ADDENDUM No. 1

REQUEST FOR QUOTATION No.: 1220-040-2023-075

TITLE: NORTH BLUFF PUMP STATION: PUMP REPLACEMENT

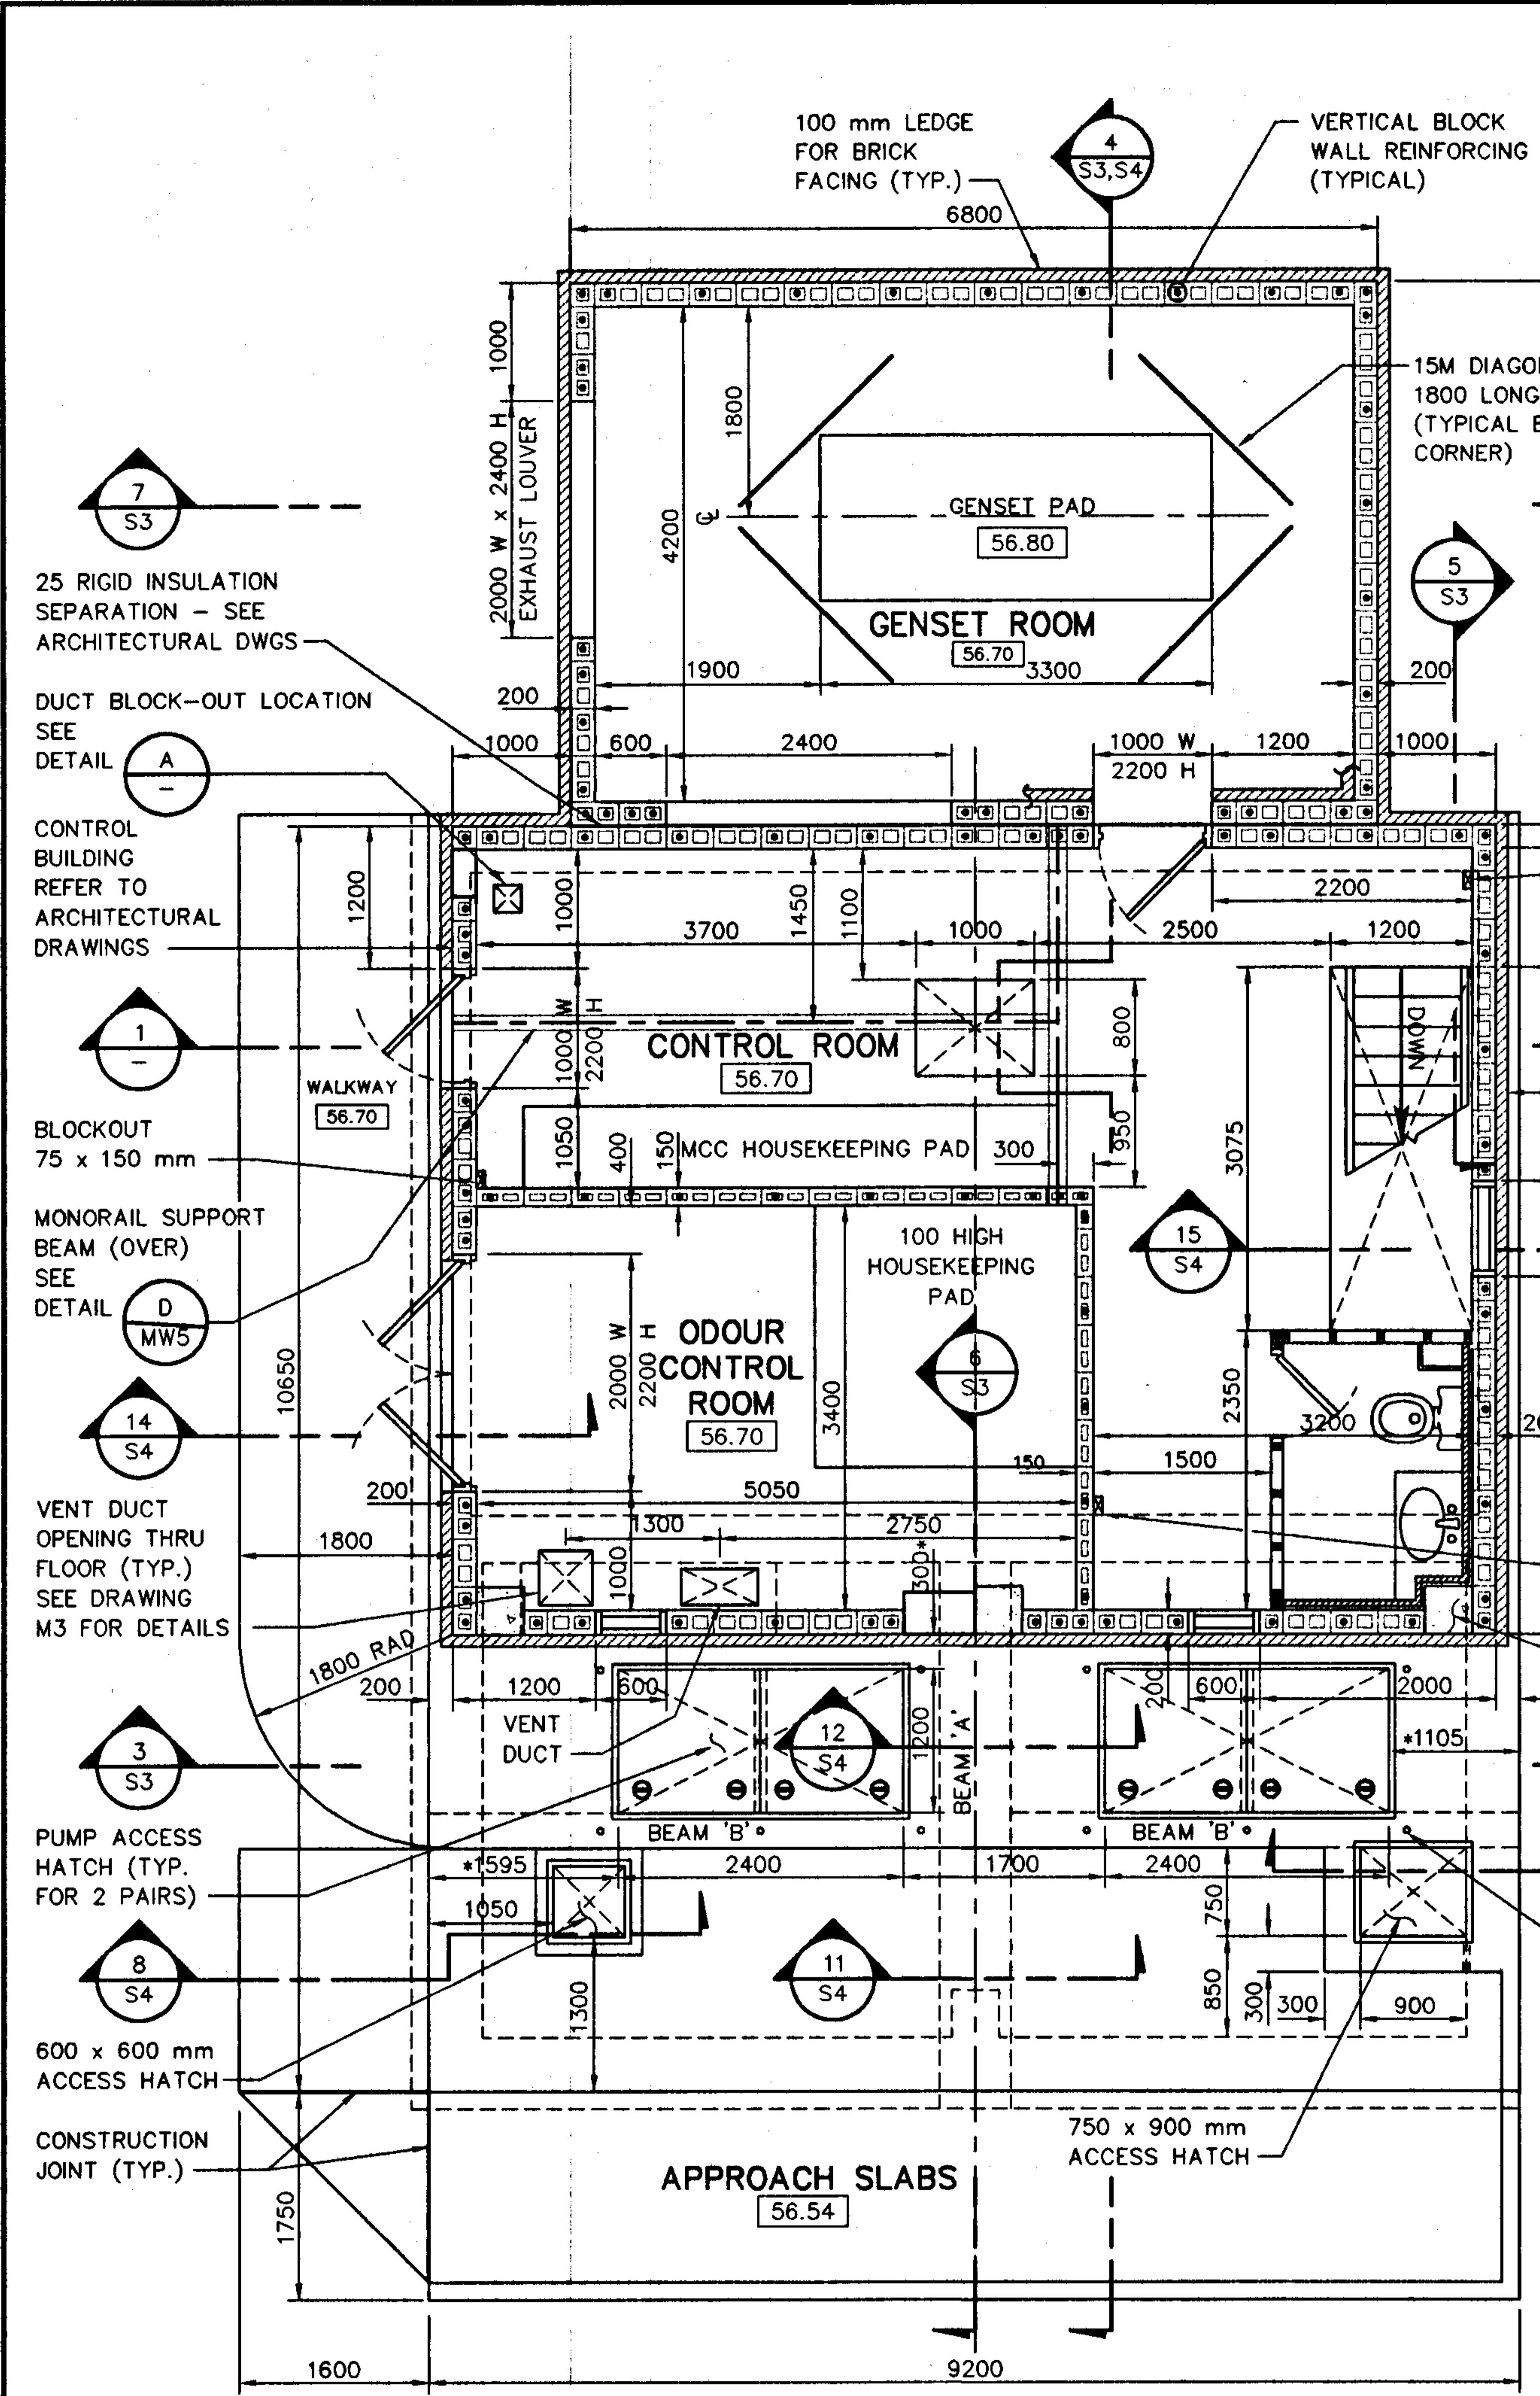
- Q7.** Are there any limitations for the individual motor-rated power?
- A7.** Yes, the current starters are rated for 135 hp with 180 amps max.
- Q8.** What is the clearance from the floor to the crane beam ??

- A8.** The limiting factor is the measurement from the hatch opening (floor) to the crane hook. This total dimension is at 68.25". If the pump is too tall, the crane will not be able to lift the pump out of the opening. The very maximum height of the entire pump including the pump's lifting shackle has to be under 68". See below photos.

CITY OF SURREY	
TITLE: STRUCTURAL CONCRETE & MASONRY (SHEET 1)	
SCALE: HOR. VER.	SURREY PROJECT NO. MS 4793-324-03
CHECKED: P.W. P.U.	S-135-210(P)
SCALE AS SHOWN	
DRAWING No. 471-005	
SHEET 12 OF 40 ISSUE B

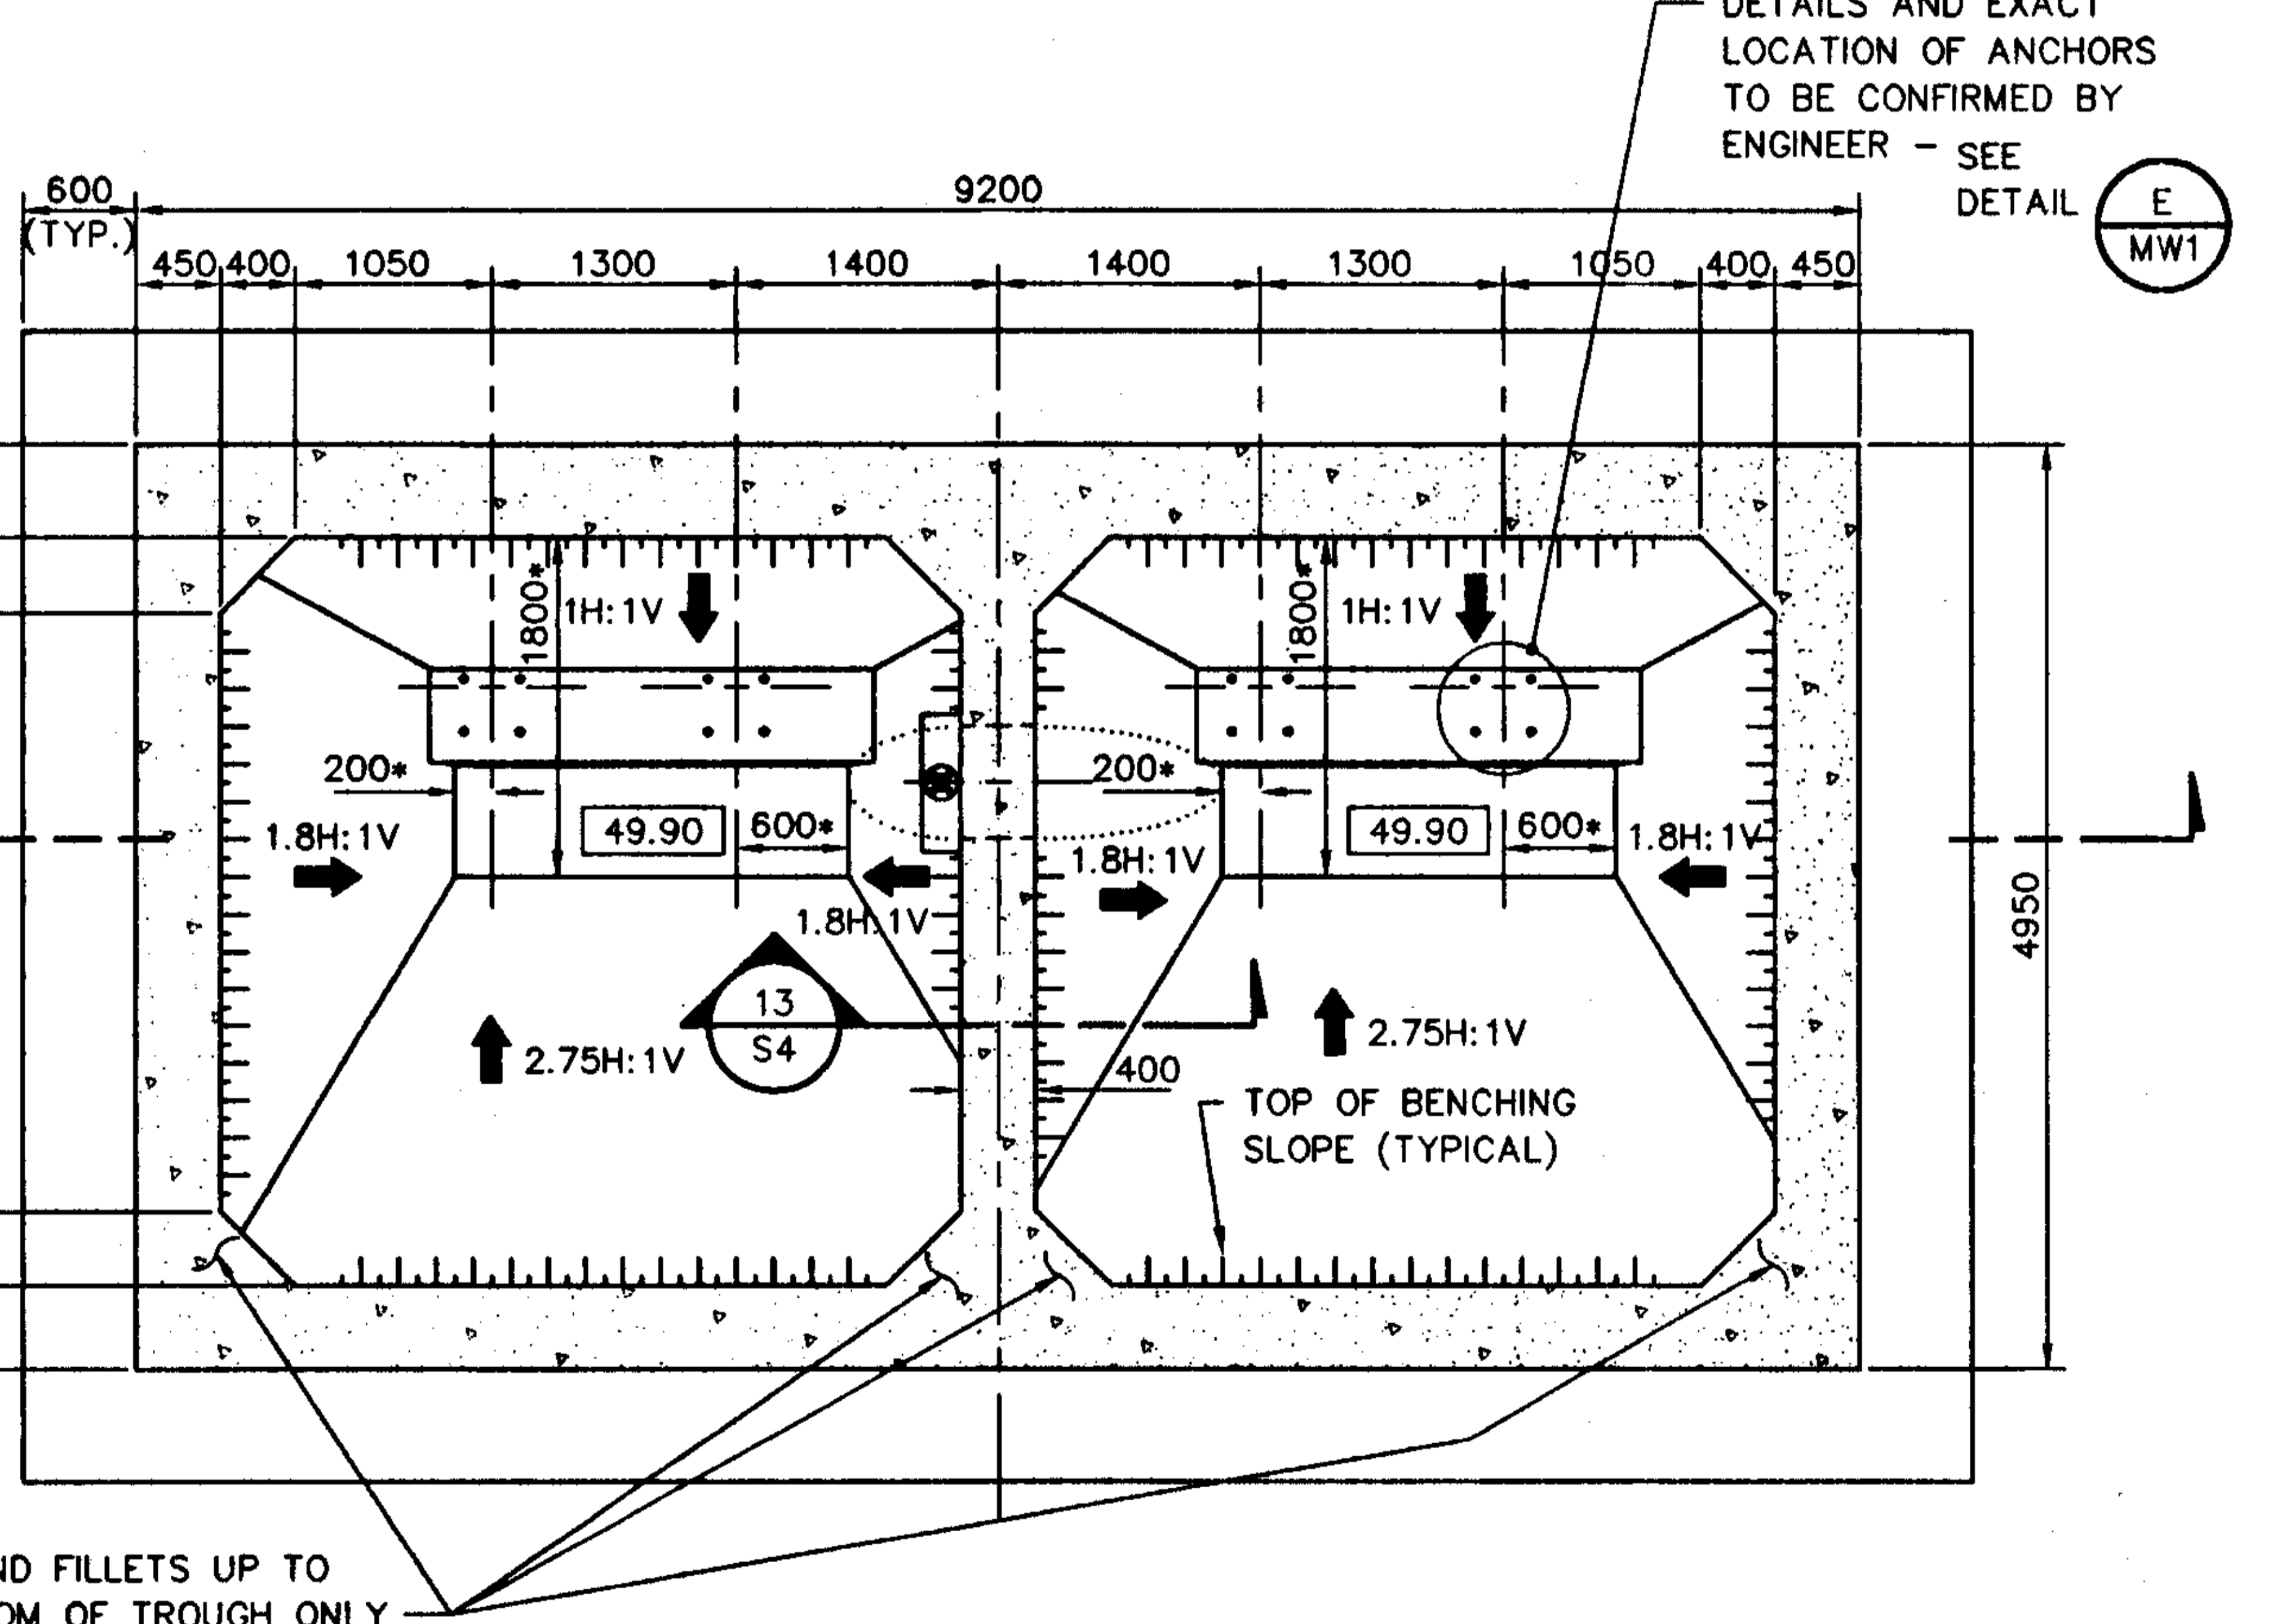
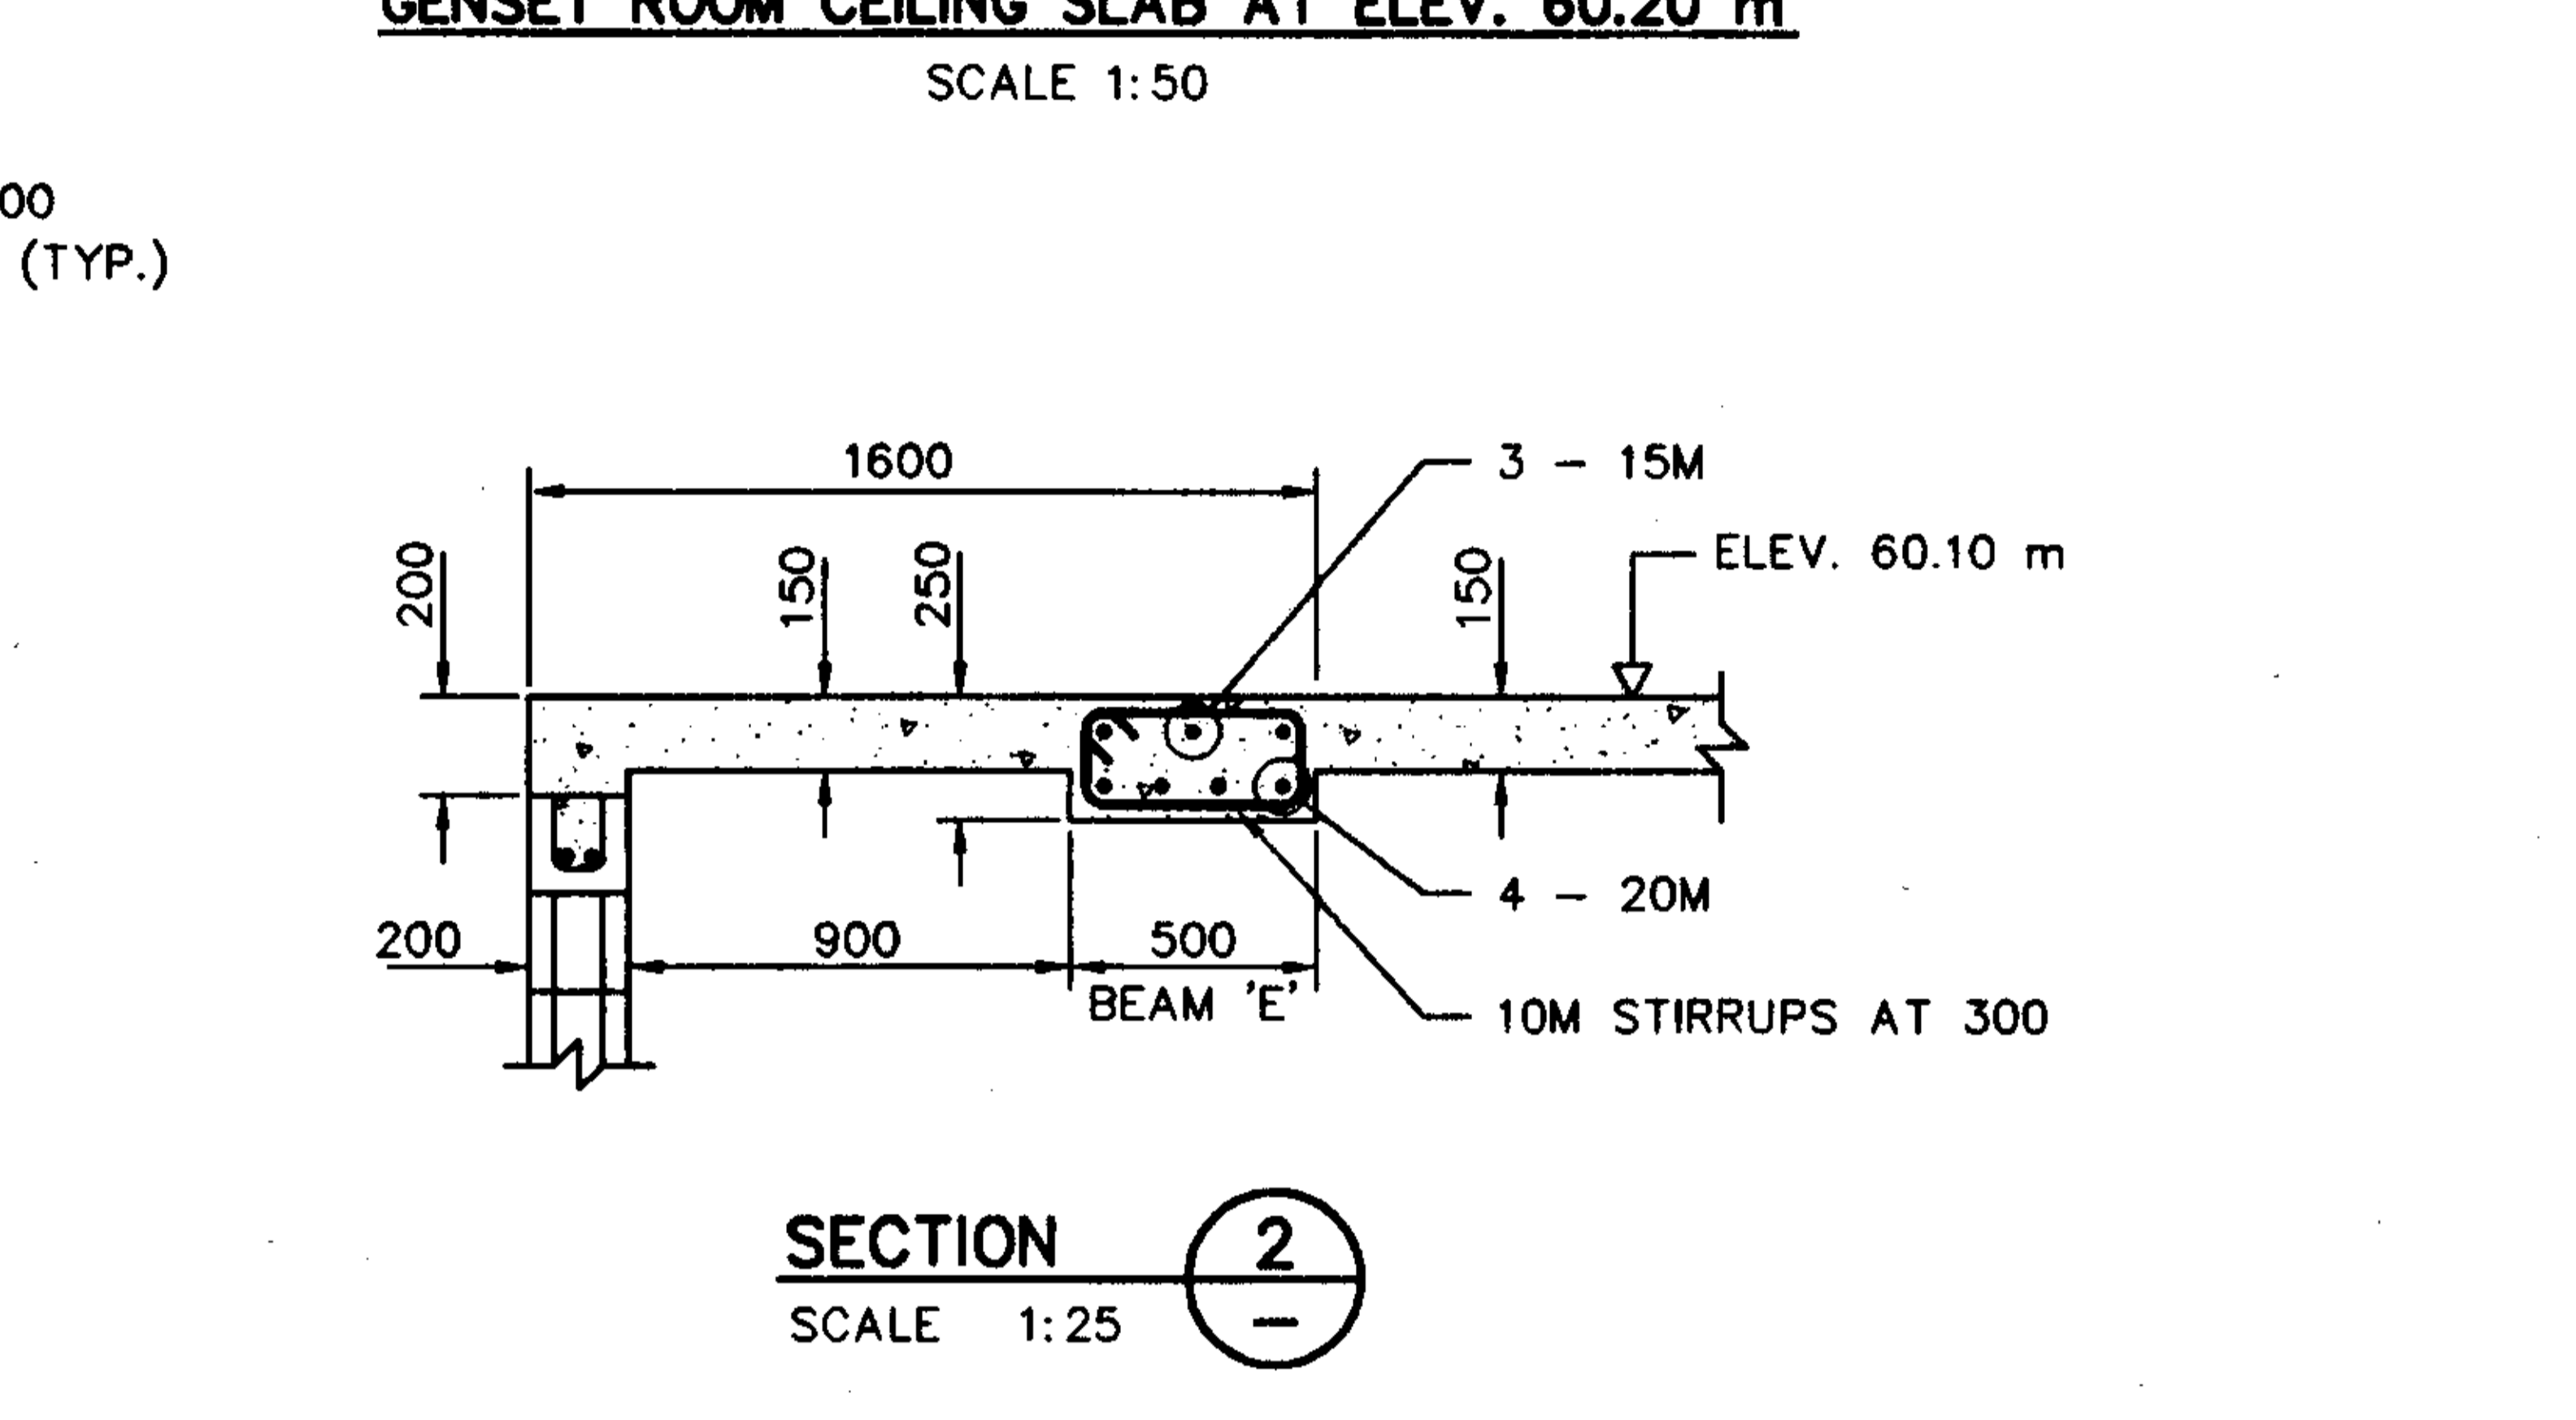
- Q6.** Please provide the hatch dimensions shown on the drawing S-135-205 (P).
- A6.** Actual opening is 42" x 42". The guide rails may not be compatible with all the pumps. If they have to be modified, it could affect the opening available space for installing/ removing the pumps. See Attachment No. 1 – Structural Concrete & Masonry on page 5 for additional information.
